BENDIX STREET, MANCHESTER

**REPORT TO DISCHARGE DRAINAGE
RELATED PLANNING CONDITION**

Report Title: Report to Discharge Proposed Drainage Related Planning Condition

Report Reference: BST-RDG-00-ZZ-RP-C-0002

TYPICAL DETAILS OF ATTENUATION TANK BASED ON ALDERBURGH PLUVIAL CUBE MODULE UNITS

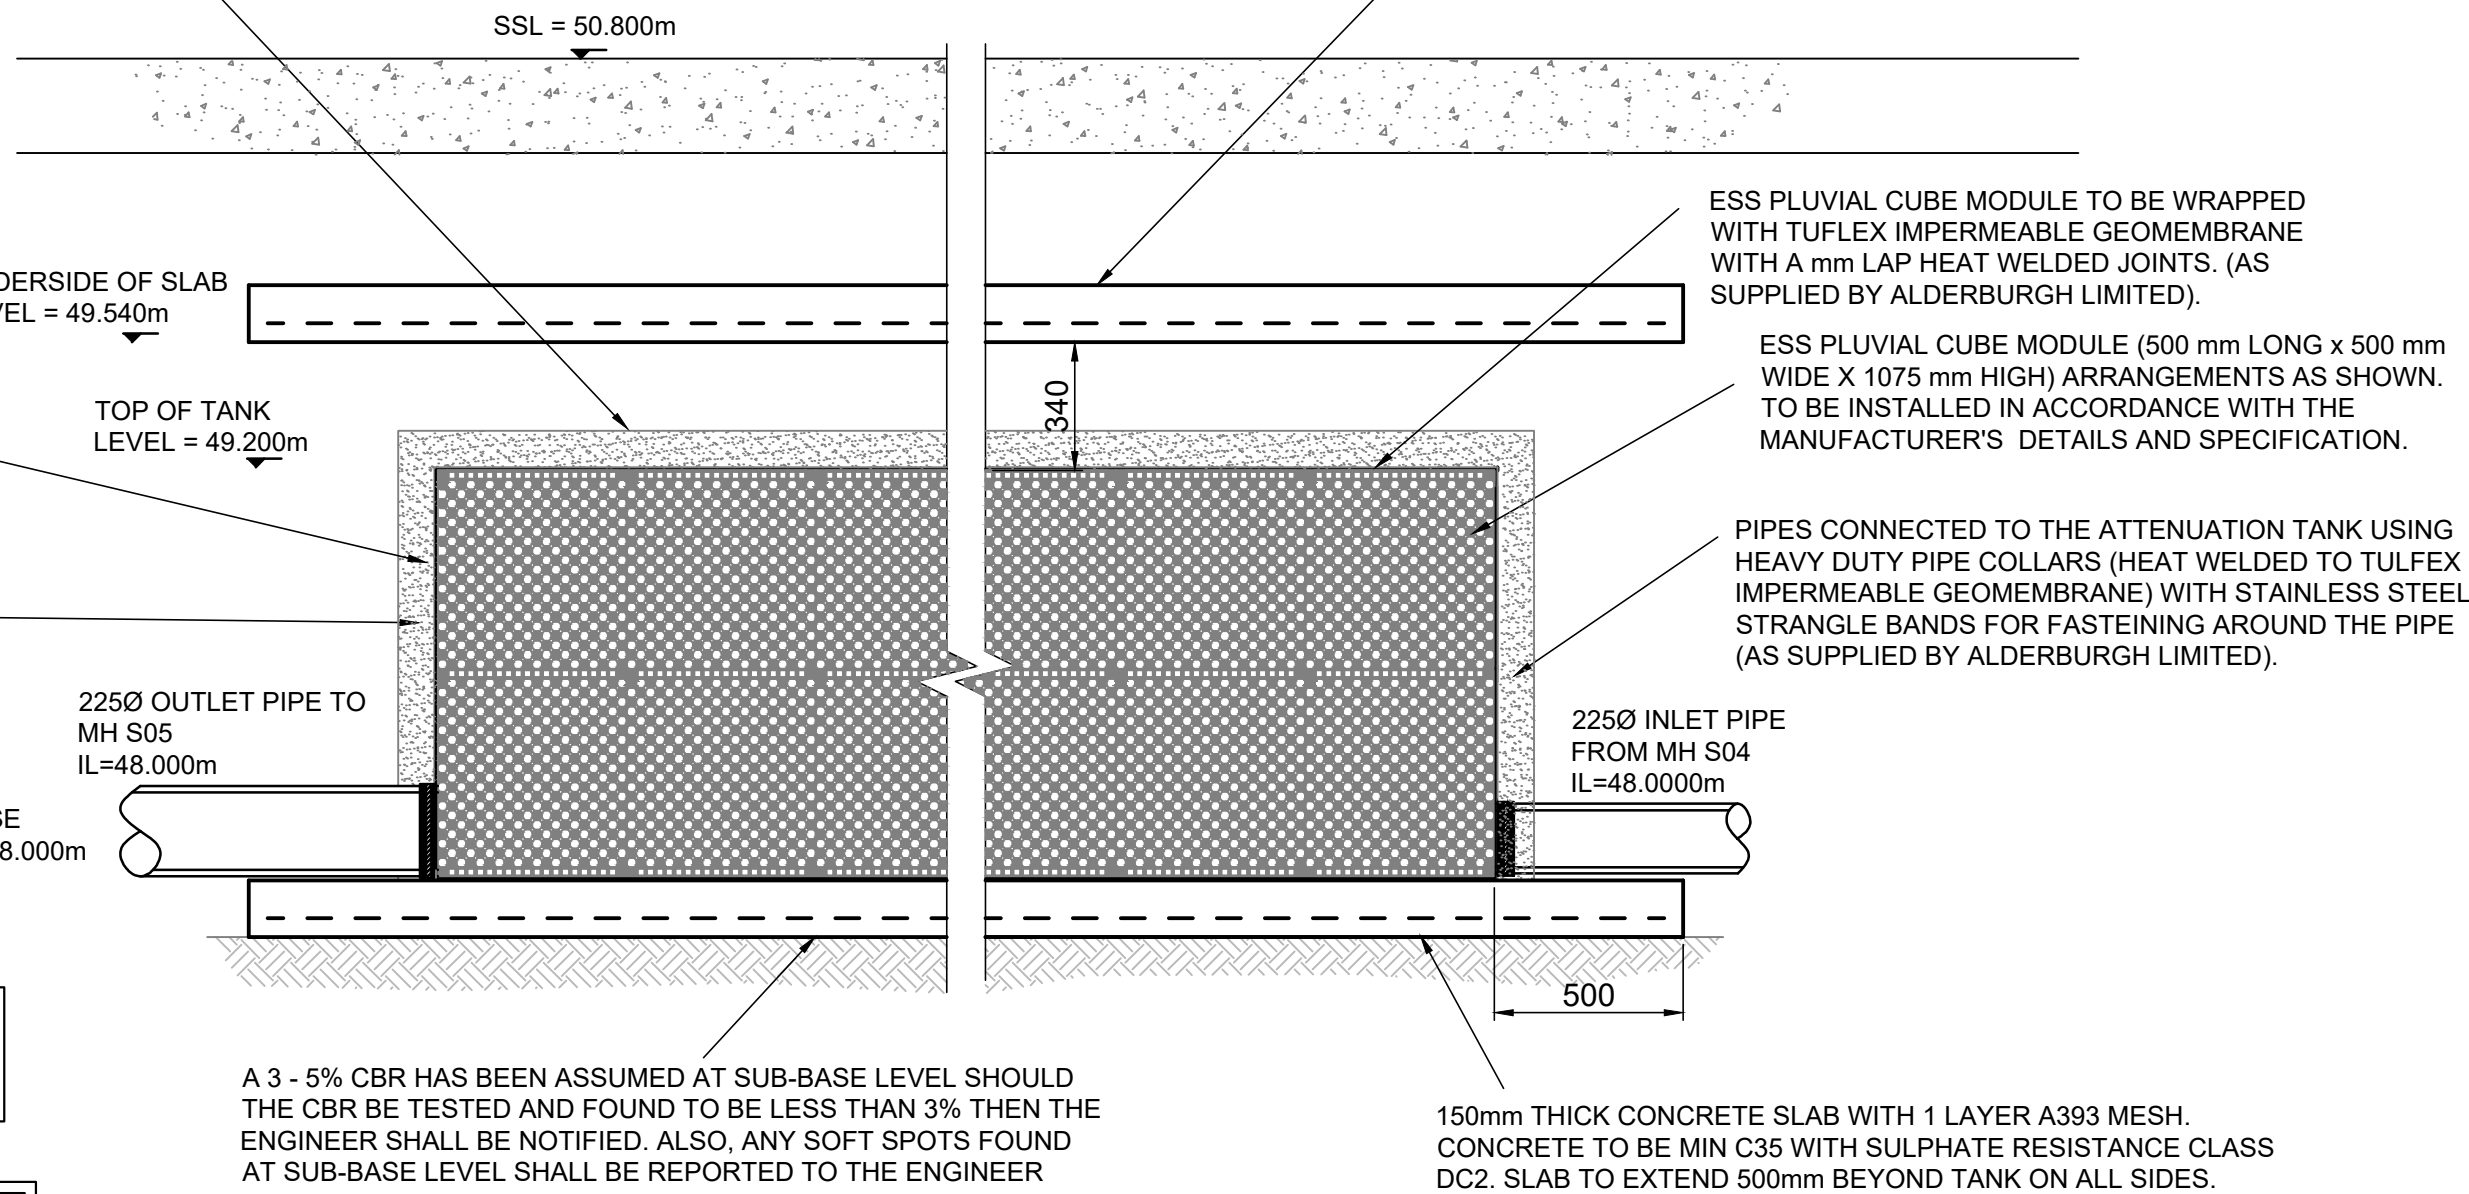
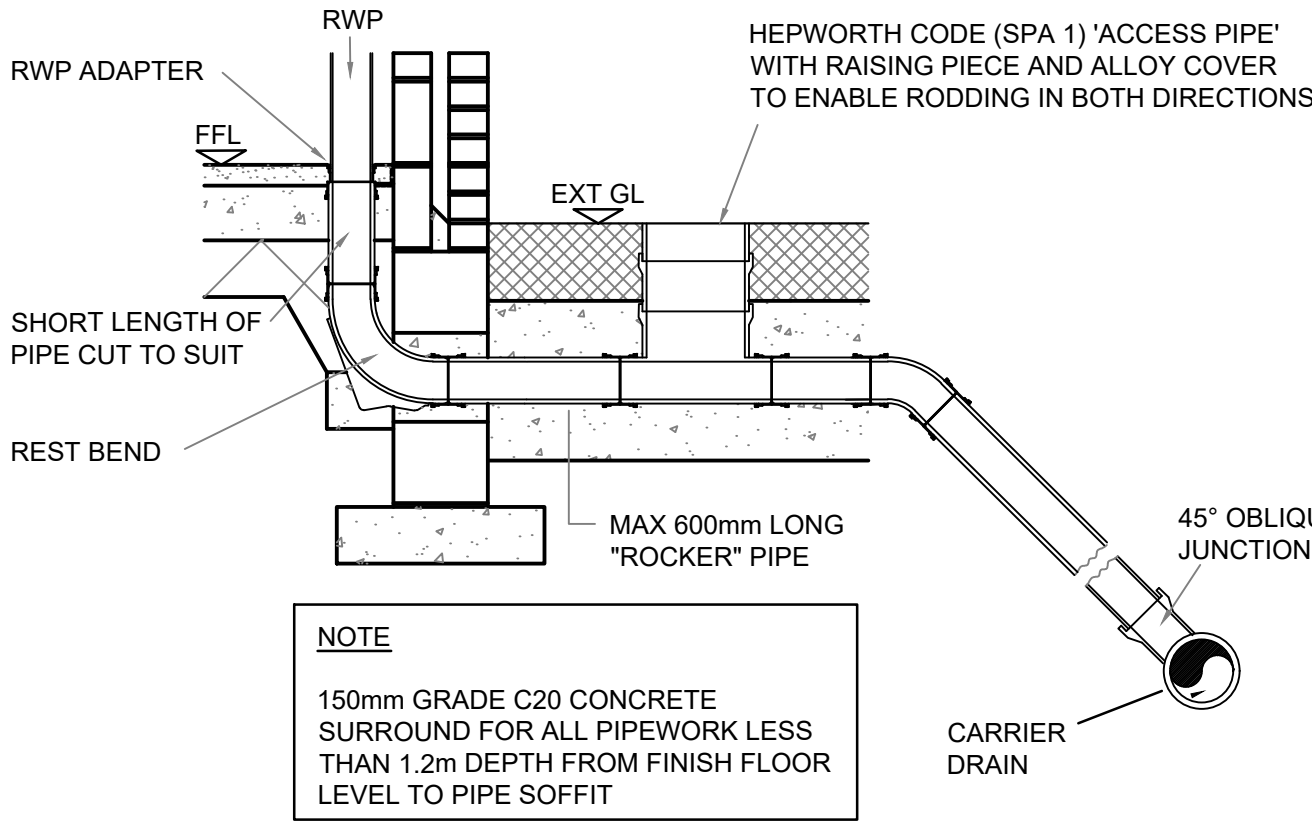
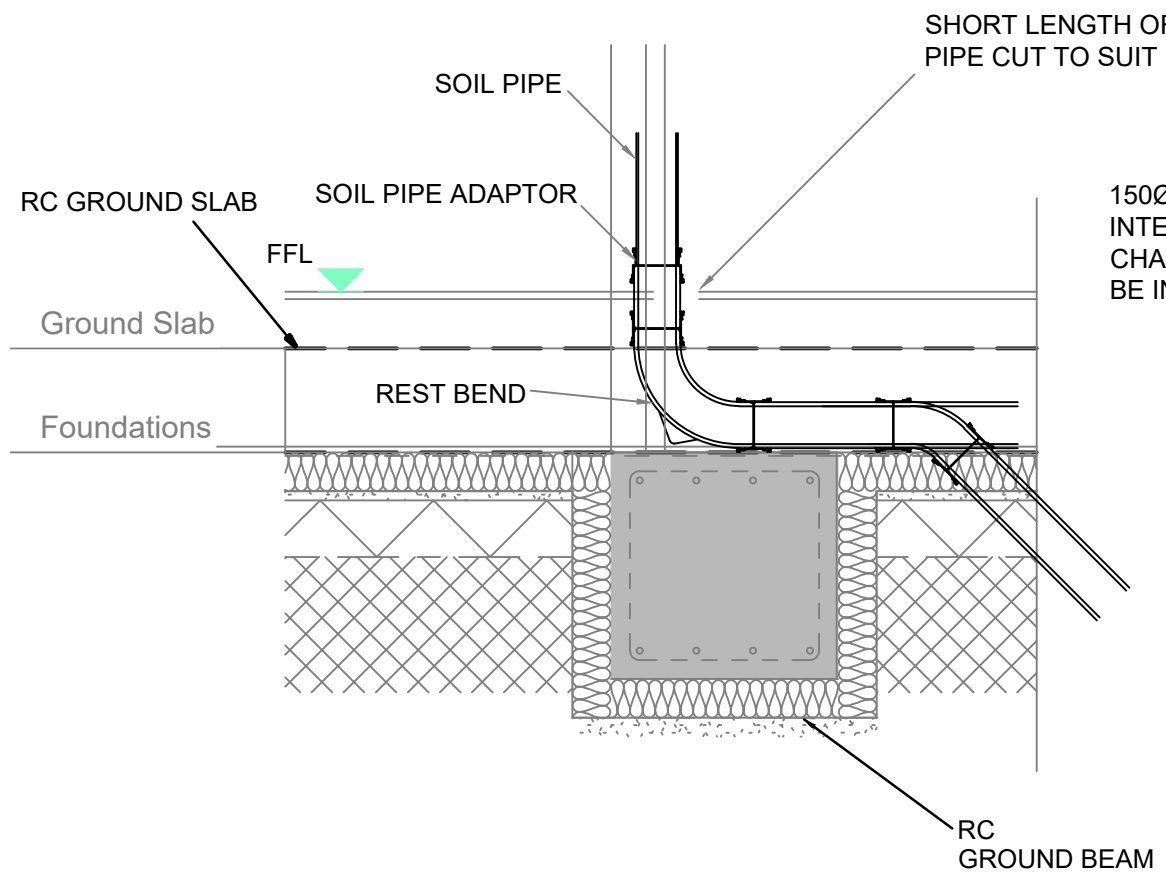
- *Construction details of flow control and SuDS elements*

For construction details refer to drawings BST-RDG-00-ZZ-DR-C-0102 & 0103 in Appendix A.
